## SERVICE BULLETIN

ENGINE – HP TURBINE ROTOR AND STATOR ASSEMBLY – PROVIDE A NEW FIRST STAGE HPT BLADE AND FIRST STAGE HPT COOLING DUCT ASSEMBLY – CATEGORY CODE 6 – MOD.ENG-72-0046

# V2500-ENG-72-0046

Location of stage 1 HPT cooling duct assembly  
Fig.1

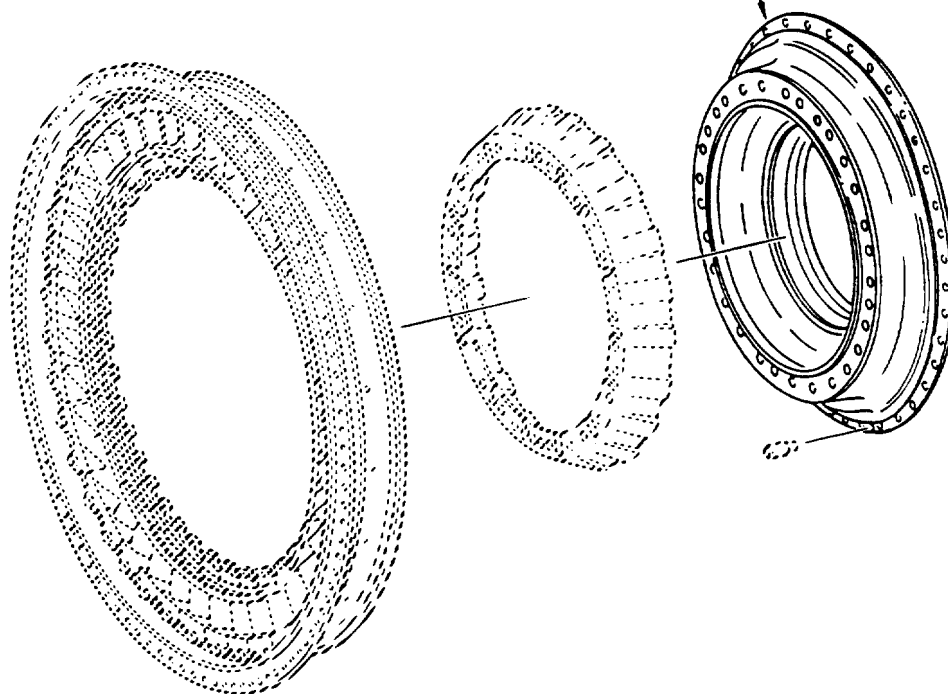
REPLACE PN 2A0008-01  
STAGE 1 HPT COOLING  
DUCT ASSEMBLY (1 Off)  
WITH PN 2A1997-01 STAGE 1  
HPT COOLING DUCT  
ASSEMBLY (1 Off)

- (ii) Use the vibration peen method.
- (4) Replace the 2A0008-01 Stage 1 HPT Cooling Duct Assembly (1 off) with 2A1997-01 Stage 1 HPT Cooling Duct Assembly, by the approved procedure in Reference (3), Chapter/Section 72-44-00, Assembly. Refer to Figure 1.

Modification of stage 1 HPT cooling duct assembly  
Fig.2 Sheet 1

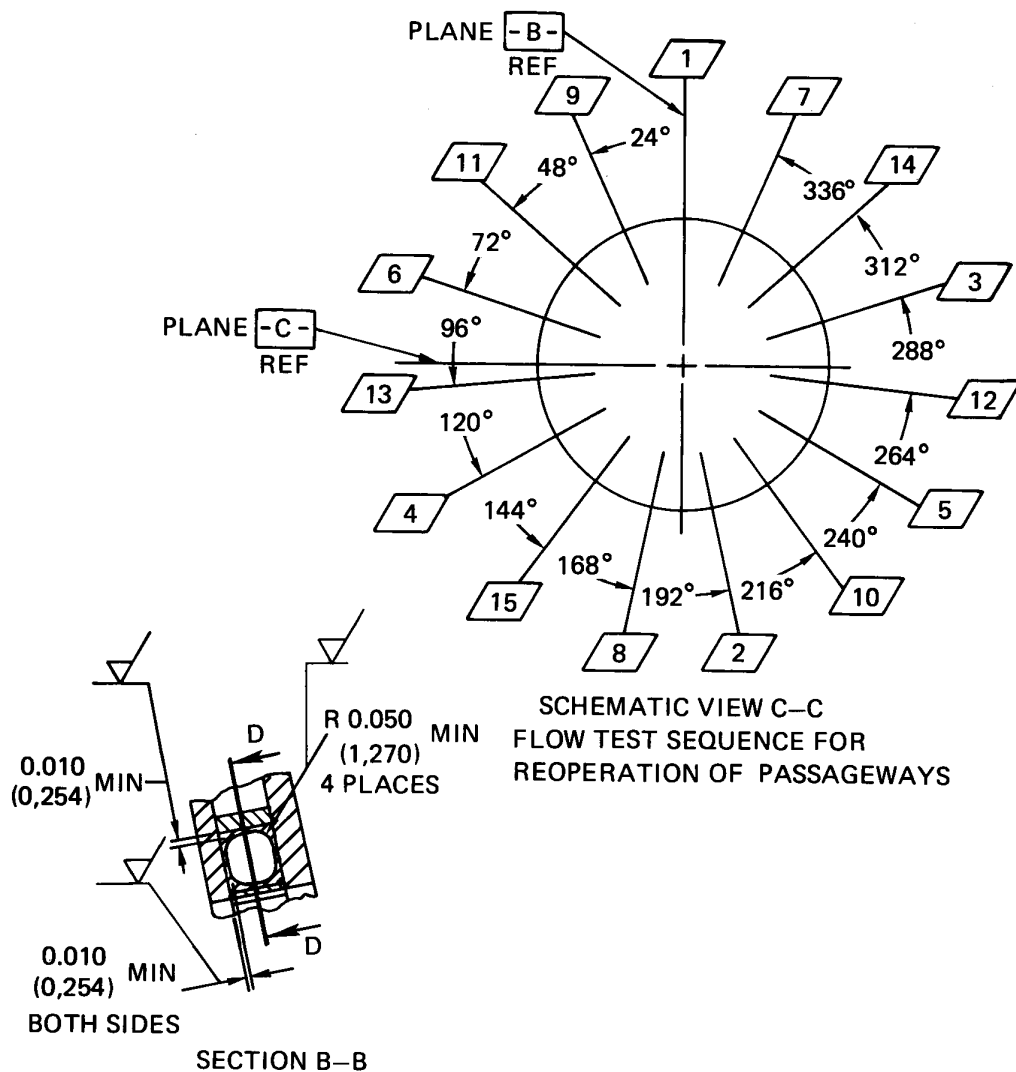
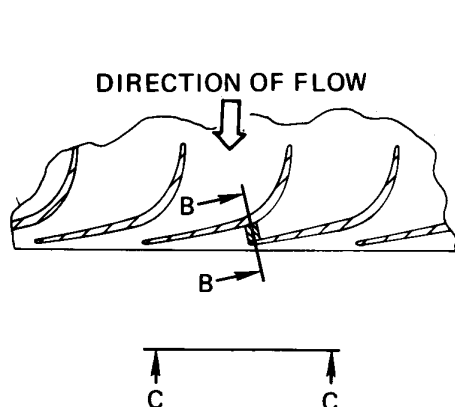
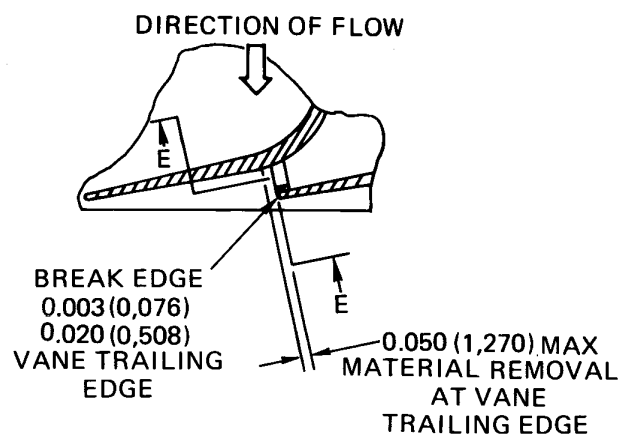
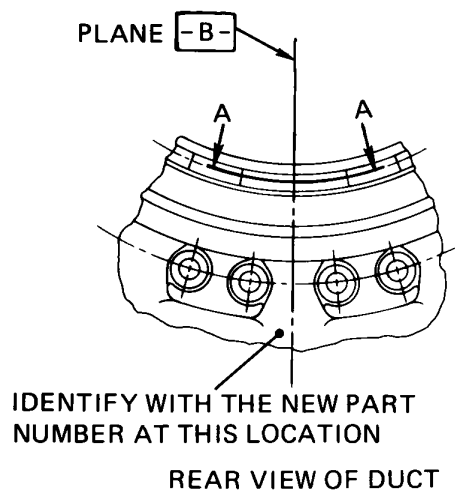
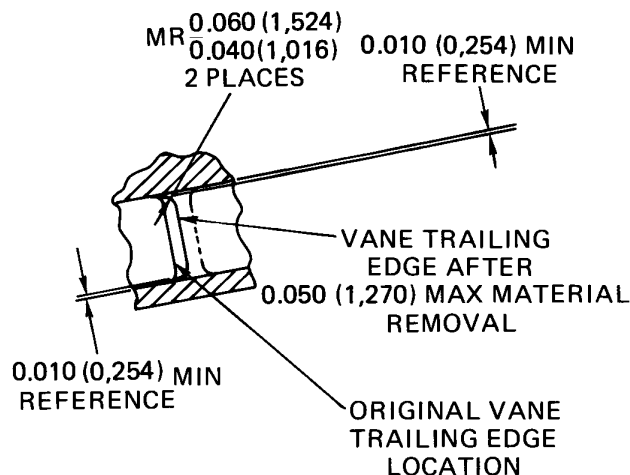
- (1) Do a modification to 2A0008-01 Stage 1 HPT Cooling Duct Assembly (See Reference (2), 72-44-50, Figure/Item No.01-010) and identify as follows:

Procedure	Supplementary Information
(a) Flow test the vane passages collectively in the direction shown by the procedure specified	See Figure 1 and Figure 2, Sheets 1 and 2, requirements. Use the procedure in Reference (3) Control No./Task No. 72-44-50-990-009 through 72-44-50-990-011
(i) Make sure that the flow is in the limit specified	
(ii) To get the specified flow rate add or make larger 1 to 15 openings, as necessary, to increase flow

- (b) Set-up and machine the Cooling Duct to open blocked passageways      See Figure 2, Sheet 1 and 2, requirements
- (i) Open passageways in the sequence shown

- (ii) Remove the material through the weld as shown
- (iii) Surface texture must be by the procedure specified      Use the procedure in Reference (4) Control No./Task No. 70-35-09-350-501

- (c) Do the flow test given in step (a) again      See Figure 2, Sheets 1 and 2, requirements. Use the procedure in Reference (3) Control No./Task No. 72-44-50-990-009 through 72-44-50-990-011.

$$\frac{W \sqrt{T_3}}{P_{AMB}} = 1.040 \text{ \& } \left( \frac{P_3}{P_{AMB}} \right)_{MIN} = 1.527, \left( \frac{P_3}{P_{AMB}} \right)_{MAX} = 1.577$$

Location of stage 1 HPT blades  
Fig.3

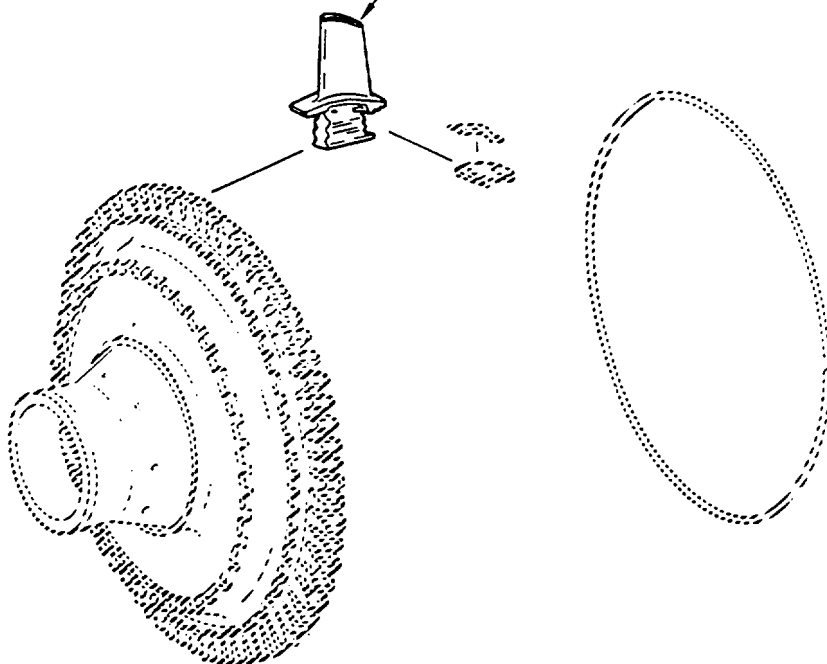
REPLACE PN 2A1721 STAGE 1  
HPT BLADES (64 Off) WITH  
PN 2A2421 STAGE 1 HPT  
BLADES (64 Off)

- (2) Send the 2A1721 Stage 1 HPT Blades (see Reference (2), 72-45-14, Figure/Item No.01-010) to the approved vendor given in the Material Information Section for a modification and identification to 2A2421 Stage 1 HPT Blades. See Figure 3.

- (1) Replace the 2A1721 Stage 1 HPT Blades (64 off) with 2A2421 Stage 1 HPT Blades, by the approved procedure in Reference (3), Chapter/Section 72-45-10, Assembly. See Figure 3.
- (2) Identify the new Stage 1 Turbine Rotor Assemblies as follows:
- (a) Identify the 2A2321 Stage 1 Turbine Rotor Assembly as 2A2521.
- (i) Use the approved procedure given in Reference (4), Control No./TASK No.70-09-00-400-501, Marking of Parts.
- (ii) Use the vibration peen method.
- (b) Identify the 2A1621 Stage 1 Turbine Rotor Assembly as 2A2721.
